Reference: Terry Type GS
Auxiliary Feed Pump Drivers
Structural Bolting Requirements

DESIGN IMPROVEMENT

DI 14

Type GS-1N & GS-2N Structural Bolting Requirements

TABULATION OF STRUCTURAL BOLTING AND TORQUE VALUES

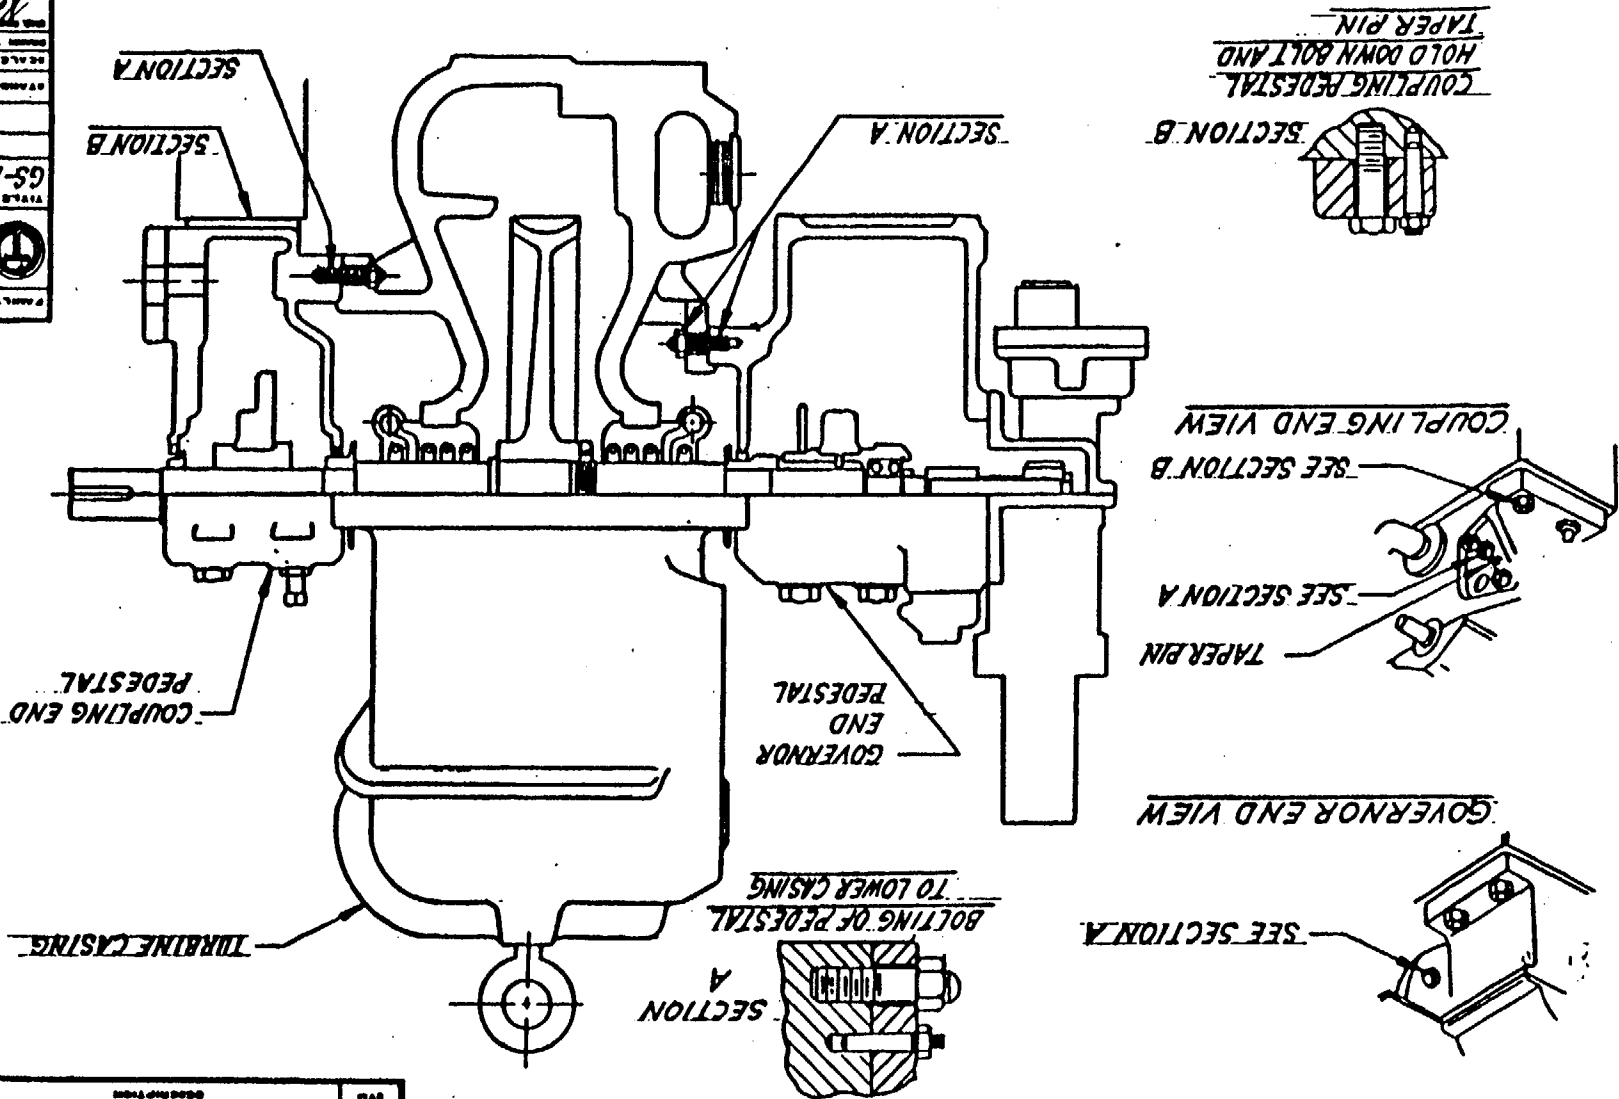
The analysis indicates three areas requiring specific minimum bolting preload; the governor end bearing pedestal to case joint (5 bolts), the coupling end bearing pedestal to case joint (7 bolts) and the coupling end bearing pedestal to baseplate joint (2 bolts). The locations of these joints are shown in Section A and Section B of drawing 131324B (attached).

The imposed bolt preload requires that the bolting material have a minimum strength equivalent to ASTM A193 Grade B-7. Some units may have been supplied with bolting materials not meeting this minimum strength and will require replacement of the bolting.

The tightening or torquing of bolts is very important and must be done with care. The angle of turn method (turn of the nut) is specified for case to turbine pedestal joint. Turbine pedestal hold down bolts can be torqued to specified torque value.

*See separate procedure for turbine pedestal to case bolts.

PROCEDURE FOR TIGHTENING BEARING PEDESTAL
TO CASE BOLTING

1. Proceed one nut at a time. Leave all others tight as found.
2. Loosen nut making sure that nut is turning on stud and that stud stays securely seated in its tapped hole.
3. Using wrench, retighten nut to snug position (approximately 10 lb-ft torque).
4. Tighten nut the additional angle of turn required for each location.
5. Proceed to next location and repeat steps 1 to 4 until all five (5) governor end and seven (7) coupling end locations are tightened.

<u>LOCATION</u>	<u>ANGLE OF TURN</u> (MIN. - MAX.)
Governor end, two studs near horizontal centerline accessible from outside of bearing box.	47° - 52°
Governor end, three studs approximately 6 inches below horizontal centerline accessible below gland case.	19° - 21°
Coupling end, six studs visible from coupling end of turbine.	47° - 52°
Coupling end, one stud bottom center accessible from under turbine	19° - 21°
